工程指示 / 要求簡箋 ENGINEER INSTRUCTIONS(E.I.)

工程指示編號:	EI- 6866 / 23	修改版本:	-
	HK- 2370 / 23		
工程編號:	J 859	工程名稱:	啟德6551
收件人:	maggie & 生統	發件人:	nero
工程項目:	後裝窗 - 廠用配件(不鏽鋼網)	日期:	20/10/2023

內容: 請按附件資料訂購不鏽鋼網, 送美而特廠。
 網窿: 12*12mm
 厚度: 1.2mm
 材料: 316不鏽鋼
 1米x30m/卷

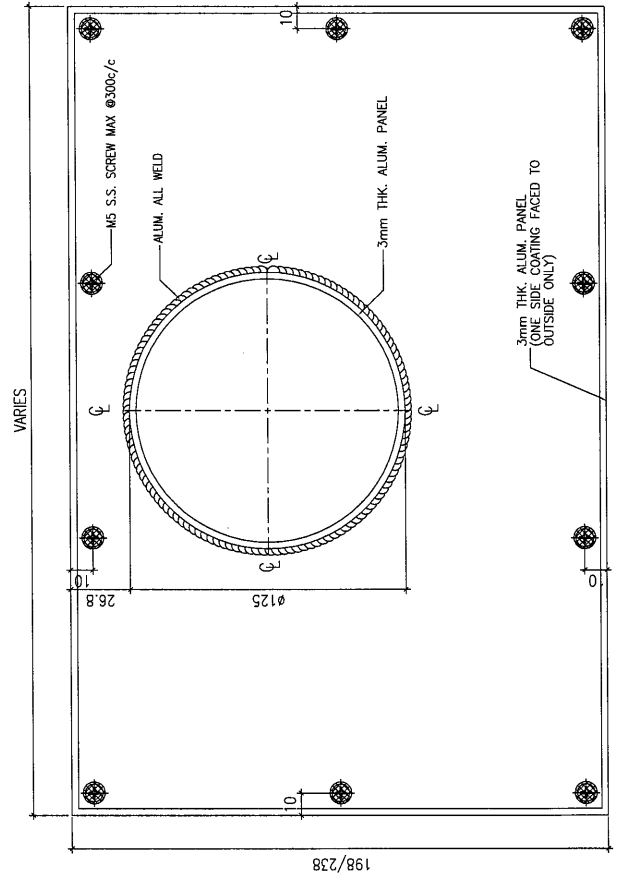
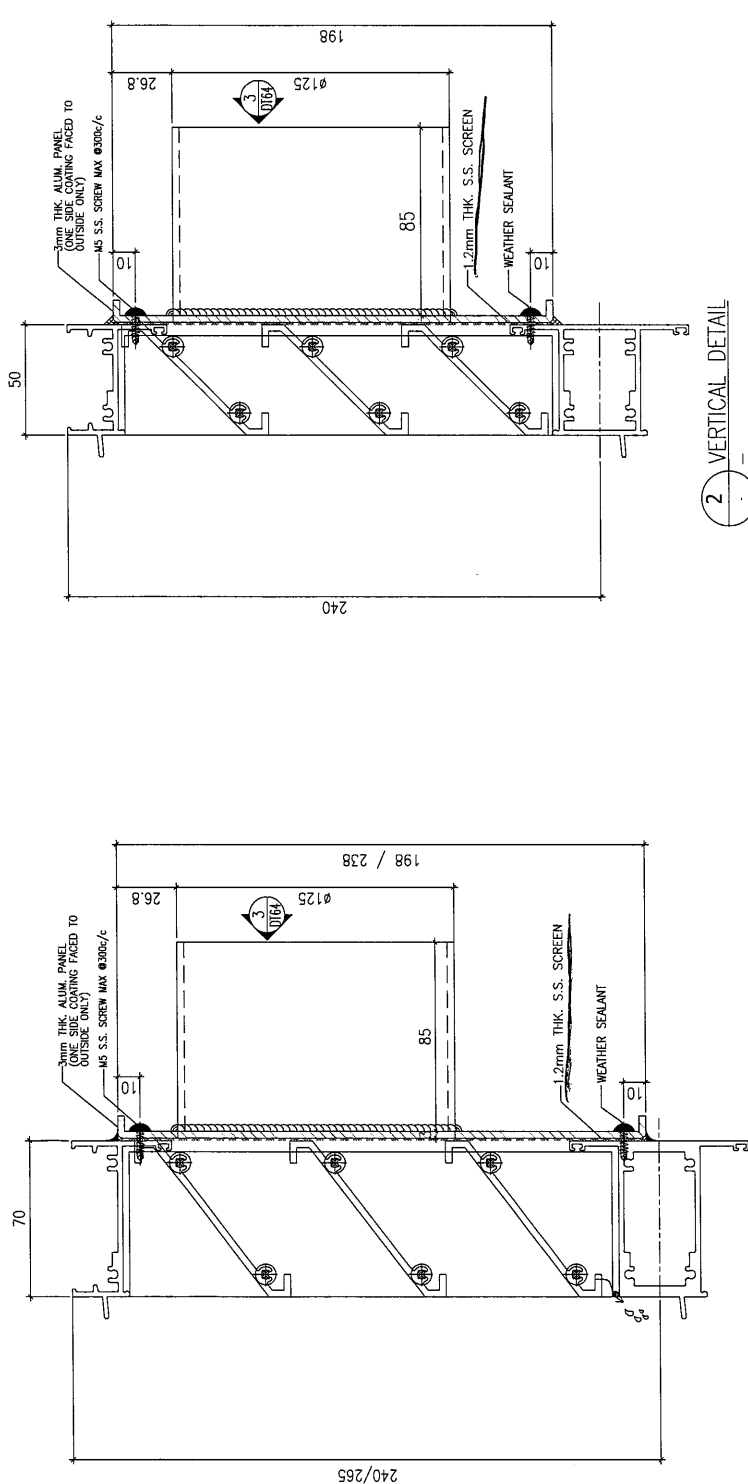
另外,
 請美而特廠按附件資料裁剪並把網安裝用後裝窗上。
